ADDENDUM

The following section pertains to pages **6, 13, 22, and 37** of the **Thunder LE S2510 User Manual Rev. 1.01**, and to the **Rev. 1.00 manual (in general)**.

About Flashing your BIOS

Figure 3.0 - Peeling back the sticker

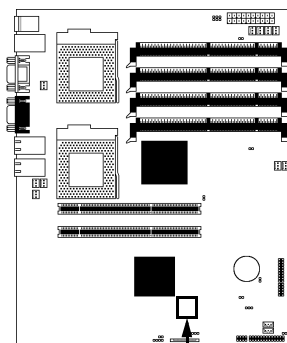
IMPORTANT! If you have a BIOS chip with part number **SST 28SF040A** (see **Figure 3.1 below**), **DO NOT** flash with a BIOS that is **below v1.04**. Otherwise, you will render your system inoperable. In order to find out if you have the SST 28SF040A, you will need to peel back the sticker (see **Figure 3.0 below**). **If you have a different chip other than the SST 28SF040A, this addendum does not affect you.**
